DHC-4807

CK 7 Federal 1 - 30015-33420
Cimarex Energy Co. of Colorado - 162683
Pool:
New - Wildcat Cisco Canyon
98220-Purple Sage; Wolfcamp (Gas)

Re: CK 7 Federal 1
API 30-015-33420
Section 7, Township 24 South, Range 26 East, N.M.P.M.
Eddy County, New Mexico.

From: McMillan, Michael, EMNRD [mailto:Michael.McMillan@state.nm.us]
Sent: Thursday, February 16, 2017 10:15 AM
To: Terri Stathem <TStathem@cimarex.com>
Subject: [External] CK Federal Well No. 1 administrative DHC application

Proposed WBD
KB - 18' above GL

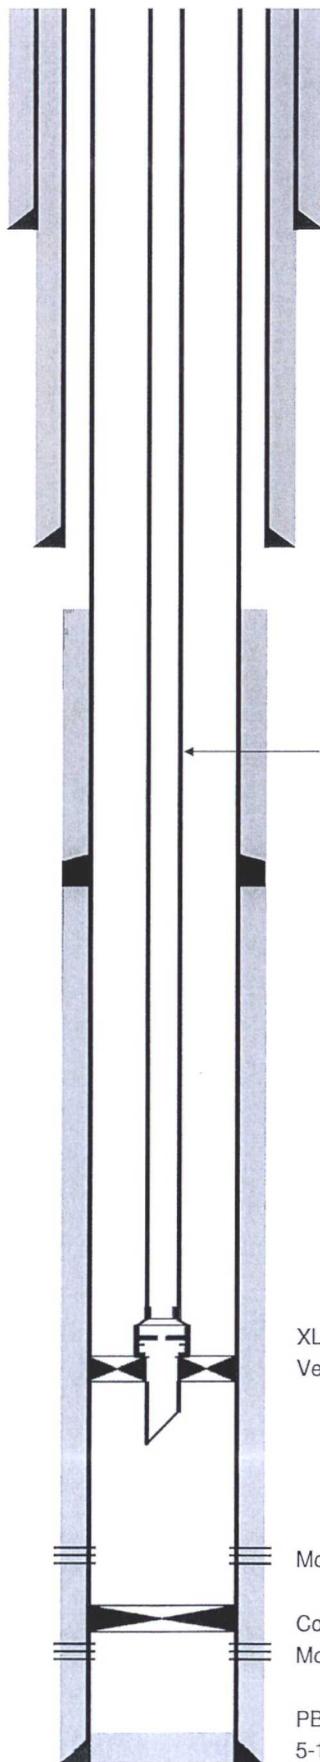
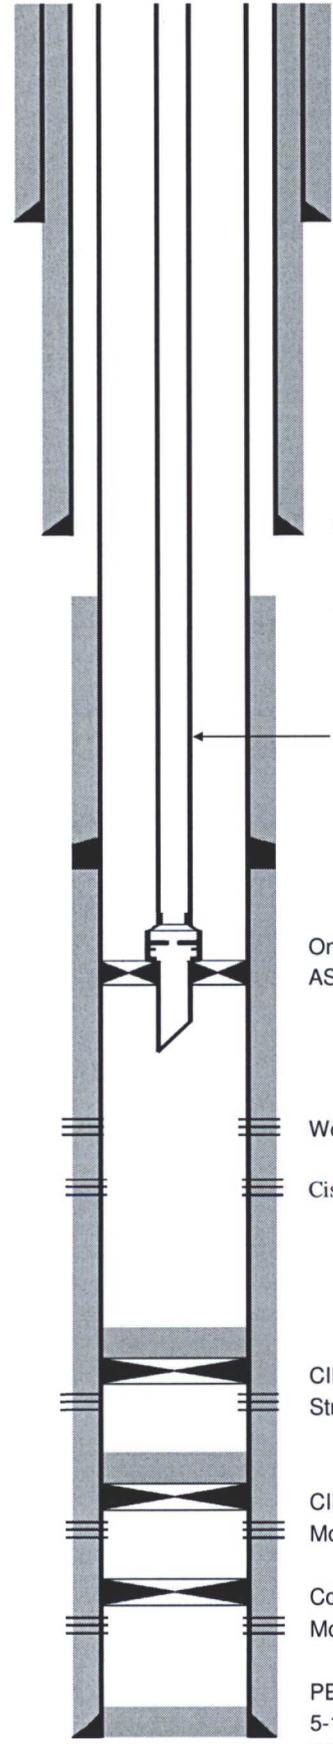
- One proposed wellbore diagram (WBD) has Strawn perms only. The other WBD shows a CIBP on top of the Strawn. I submitted two proposed wellbore diagrams. 1 for a successful Strawn completion 1 for an abandonment of a unsuccessful Strawn completion and completing the Cisco Canyon and Wolfcamp.

- Please check the perms in all of your diagrams. You show the Strawn perms from 10639`-10862` this is the top and bottom of the Strawn – we will perf within this interval but not the entire interval on one WBD. Your Wolfcamp perms are from 8748`-10639` this is the top and bottom of the Wolfcamp – we will perf within this interval but

not the entire interval with a CIBP at 10654' on the other WBD. The Wolfcamp bottom and the Strawn top are the same 10639'.

- The OCD will require corrected WBD. When the well is plugged back we will file the current wellbore diagram to correct any proposed vs. actual perms and setting depths of CIBPs.
- If the application is for the Wolfcamp -Cisco/Canyon only, the OCD will expect the workover procedure to be updated. This is for Strawn first, then Wolfcamp Cisco Canyon.
- This same situation occurred in your last DHC application. The situation before was a bit more confusing question: were we planning to commingle Strawn Wolfcamp and Cisco? Once we gave you all the information on abandoning the Strawn we were able clear up questions. We will not commingle any formations except for Wolfcamp and Cisco Canyon. We will test the Strawn and if commercial produce only the Strawn and abandon our Ciscamp plans.
